CMD 23-M3

## Written submission from **CNSC Staff**

Responses to the questions from the **External Advisory Committee** regarding the update on the discovery of elevated hydrogen equivalent concentrations in the pressure tubes of reactors in extended operation

CNSC Staff Response to the External Advisory Committee Questions Regarding CMD 22-M37

Figure 1: Overview of fitness for service evaluations for flaws in pressure tubes

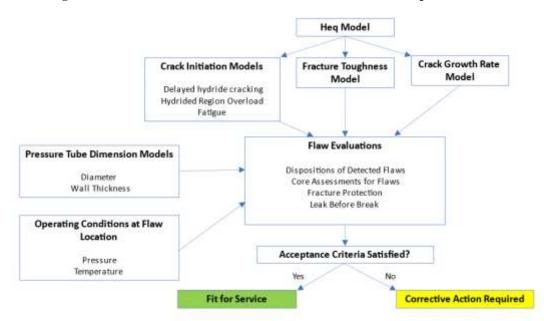
- For the current situation, with regions of elevated Heq near the burnish marks, the uncertainty in the output from the models that predict and rely on the Heq in the pressure tube prevent definitive conclusions from being made regarding satisfying the acceptance criteria. Alternate approaches have been adopted on a temporary basis, as discussed in CNSC staff CMD 22-M37, to assess the impact of pressure tube flaws near the burnish mark on safe operation. The descriptions on the following pages present key issues that need to be addressed from the elevated Heq findings that would allow licensees to return to the process presented in Figure 1 for pressure tubes in extended operation.

Figure 4: Potential impact on redistribution of hydrogen due to temperature gradients

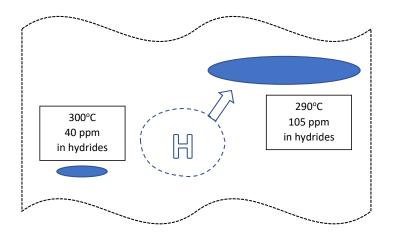
The current theory being proposed by licensees considers the potential for local regions of the pressure tube that are cooler than others when the reactor is at full power. So, for example if the temperature at the bottom of the pressure tube is 300°C and at the top of the pressure tube it is slightly lower at 290°C, the soluble hydrogen will be attracted to the cooler material at the top of the tube. This will potentially increase the amount of hydrogen at the cooler spot. If the material has an average Heq = 100 ppm, approximately 60 ppm would still go into solution, but some of the soluble hydrogen will diffuse to the colder spot. Moving hydrogen to the colder part of the tube will have a similar effect as cooling the material so the cool spot will become supersaturated.

The solubility for cooling the material to 290°C is about 105 ppm. If sufficient hydrogen moves to this location to locally increase the concentration to this value, then hydrides will start to form at the cool location and become fixed. This process will lead to a variation in the Heq between the warmer and the cooler part of the pressure tube as illustrated in Figure 4. Then when the material is cooled further during a shutdown, all of the remaining soluble hydrogen will form hydrides. As more hydrogen is added to the material and thermal cycling continues with shutdown and restart cycles additional hydrogen can build up in the cooler parts of the pressure tube, locally elevating the Heq even further because only a fraction of the solid hydrides can be redissolved.

- Does the modelling reproduce the Heq gradients that were measured in the in-service pressure tubes with elevated regions of Heq?
- Can the Heq gradients be explained by temperature, concentration and stress gradients alone or is there an indication that alternate sources of hydrogen ingress into the material are required?

- Do the regions of elevated Heq continue to expand axially and circumferentially and, if so, by how much?
- Can the model explain why only some tubes appear to be affected?

Figure 10: Effect of increasing Heq on pressure tube fracture toughness

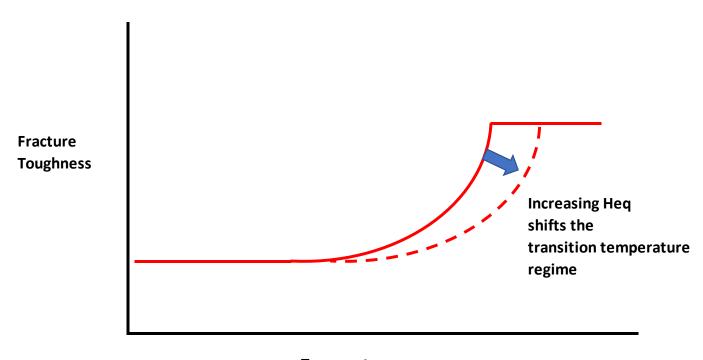
Figure 10 illustrates what happens to the fracture toughness when the material Heq increases. In the transition region, the fracture toughness reduces for a given temperature and it is also possible for the temperature for the change from the transition temperature regime to the upper shelf regime to increase.

Additional testing of material with higher Heq values is necessary to confirm that the shift in the fracture toughness will not impact safe operation of pressure tubes while starting up and shutting

down the reactor and provide confirmation that the temperature for the change to upper shelf behaviour remains below the full power operating temperature.
